Access Compliance Report Public Rights-of-Way (Pedestrian Signals)

Main Street: **NEWPORT_BLVD** Cross Street: **ROCKHURST_ST** Location: **NW**

ADA ID: **SGRK211012150638** Signal Type: **One Push Button-APS** Overall Compliance: **No** Severity Scores: **BTN 1: 25** **BTN 2: N/A** **No BTN: N/A**

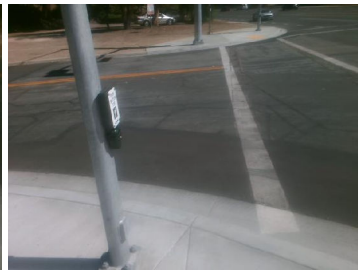
OC Std/PROW: **R404.2**

Possible Solutions: Remove and Replace Clear Space.
